MELBOURNE METRO RAIL PROJECT ENVIRONMENT EFFECTS STATEMENT INQUIRY AND ADVISORY COMMITTEE

MMRA TECHNICAL NOTE

TECHNICAL NOTE NUMBER:	011
DATE:	26/07/2016
PRECINCT:	CBD North
MAP BOOK REFERENCE:	Map 7 (Horizontal Alignment Plans – construction phase)

SUBJECT:	Provision for electrical adit between Franklin
	Street and Swanston Street

A: EES Map 7 annotated to show the location of the additional adit

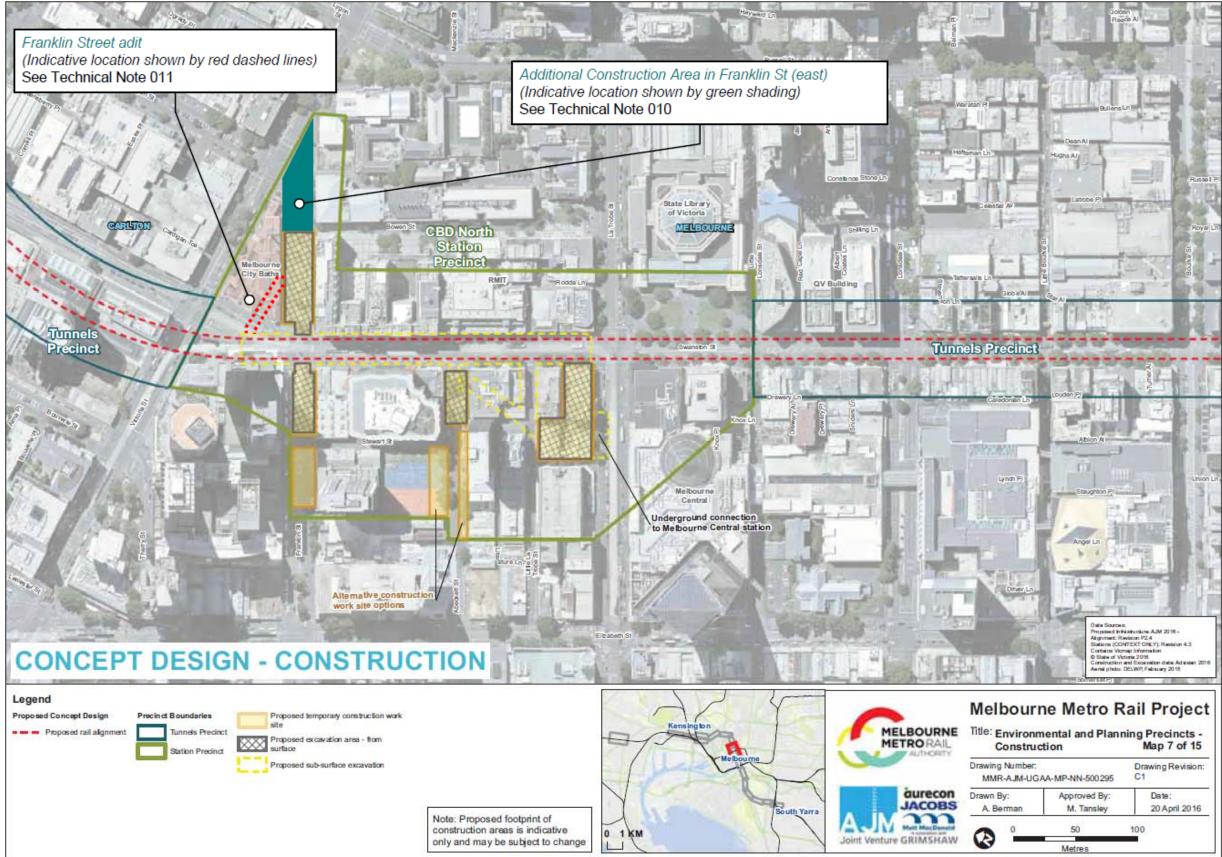
- 1. The Concept Design for the CBD North Station assumes that adits are required to support construction and provide connections to various station components.
- 2. The largest adits would provide for connection to the entrances in Franklin Street and Latrobe Street, and for connection to the Melbourne Central station.
- 3. An adit under the Melbourne City Baths would contain a high voltage electrical cable that had previously been located underneath Franklin Street. It will connect the northern end of the station box to the traction power transformer rooms located in the Franklin Street shaft.
- 4. This adit would pass under the Melbourne City Baths at an approximate depth of 25m.
- 5. Realignment of the adit would simplify the electrical cable route and provide further offset from the public access adit for the Franklin Street entrance.
